DEVELOPMENT APPLICATION

PDPLANPMTD-2026/058902

PROPOSAL: Signage, Seven warehouses (Storage) and Car Rental Facility (Transport Depot and Distribution)

FURTHER INFORMATION REQUEST - PLANNING APPLICATION - PDPLANPMTD-2026/058902 - 32 KENNEDY DRIVE, CAMBRIDGE WITH ACCESS FROM MCRORIE COURT

Site Plan 01
 Revision: DA - 02
 Approved by: JRD

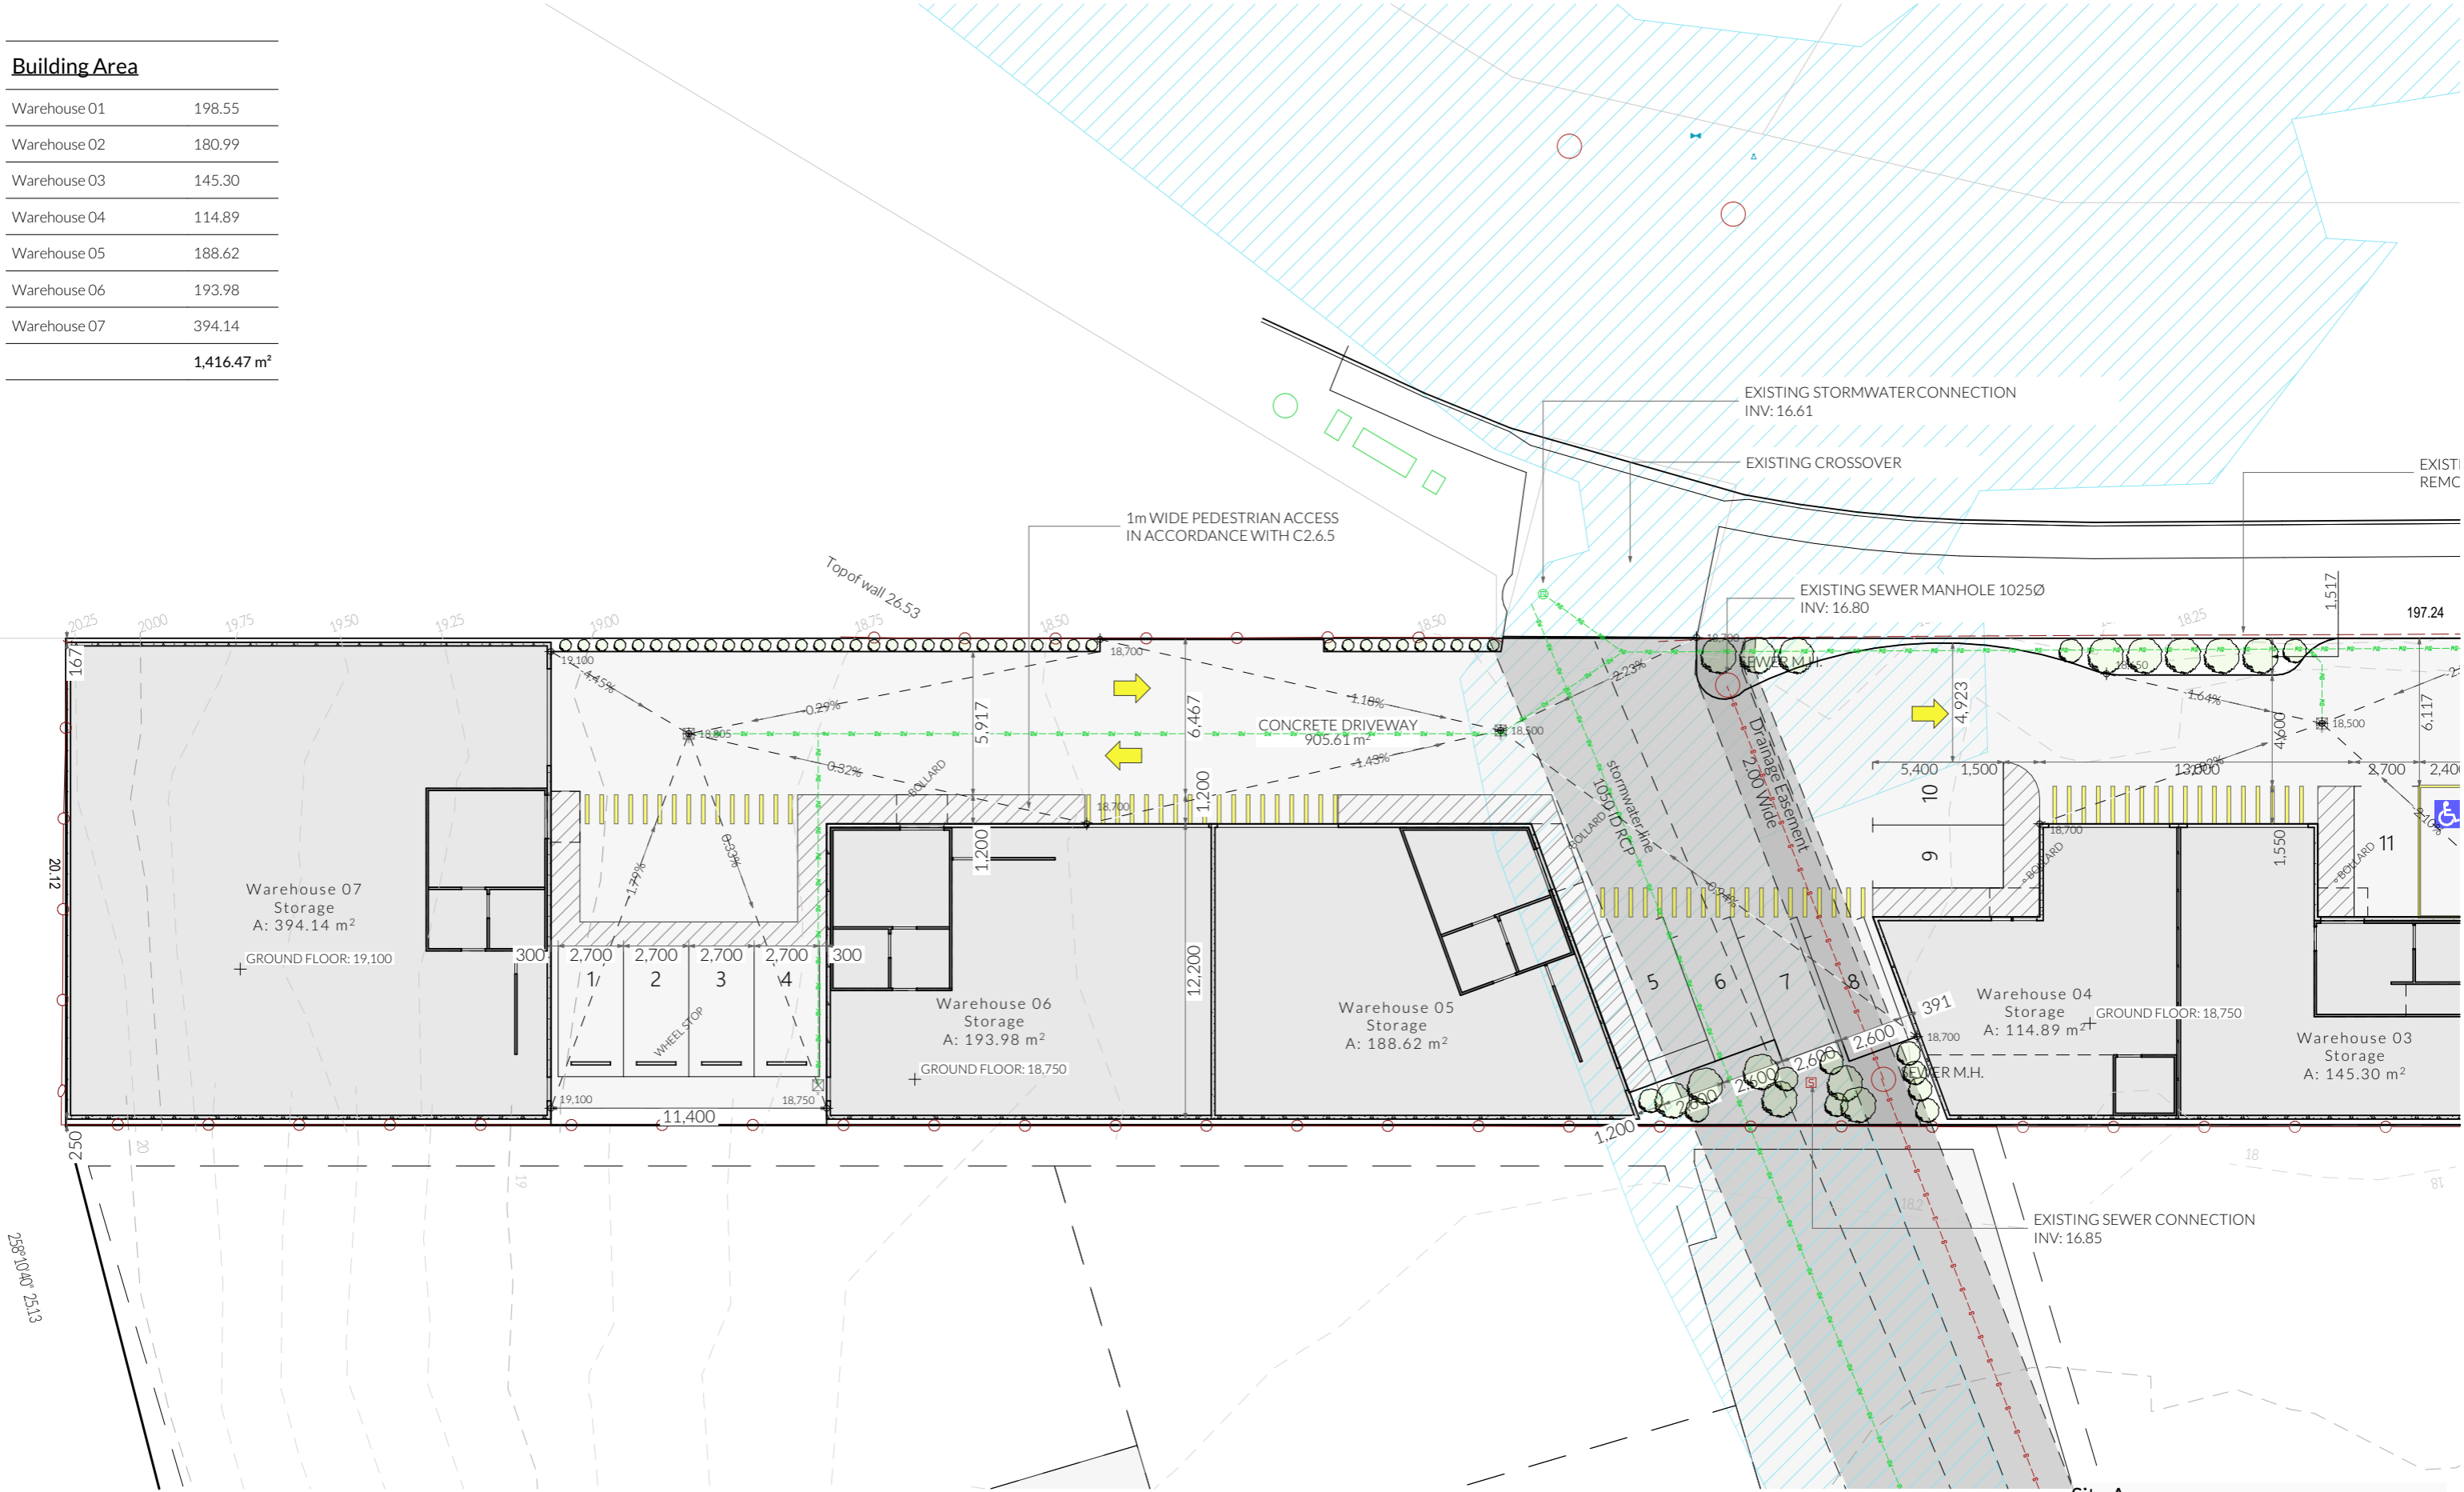
Clause 18.4.2 A2 Setbacks - Proposed units 1 and 2 would provide a 1.167m setback from the McRorie Court frontage which is below the 5.5m setback required by the acceptable solution. The setback does not appear to satisfy the performance criteria in that the frontage setback will not provide space for vehicle access, parking and/or landscaping and is not commensurate with the setback of buildings on adjacent properties. Amended plans providing for a greater frontage setback will be required to achieve compliance with the performance criteria.

Clause 18.4.5 A1 Landscaping - A landscape plan with dimensions for the frontage landscaping to confirm the depth of the landscape areas noting the acceptable solution requires landscaping to a depth of no less than 5.5m. It is noted the landscaping concept shown does not appear to meet the performance criteria in that the landscaping will not be of a sufficient depth to achieve consistency with landscape buffers provided within McRorie Court and to achieve meaningful landscaping along the frontage.

The existing shed on McRorie Court is set back 1.17m from the frontage. With a minimum setback of 1.17m, the proposed buildings in the application were compliant with A1(b). The setback of Units 1 and 2 has been increased to 2.17 to allow additional space for landscaping in the current plans (Attachment 2).

The plans (Attachment 2) illustrate landscaping on the McRorie Court frontage. The existing landscaping is retained in a bed depth of 3.02m between the Motor Vehicle Hire parking and the frontage. There is new landscaping to a depth of 2.17m between Warehouses 1 and 2 and the frontage, and to the maximum depths possible in front of Warehouses 3 and 4 (up to 1.52m) given the need to provide for vehicle swept paths. As the existing shed is setback 1.17m from the frontage, provision of landscaping to a depth of 1.17m or greater is compliant with A1(b) and this depth is achieved along much of the frontage, but not all achieves this and as such assessment against P1 is required.
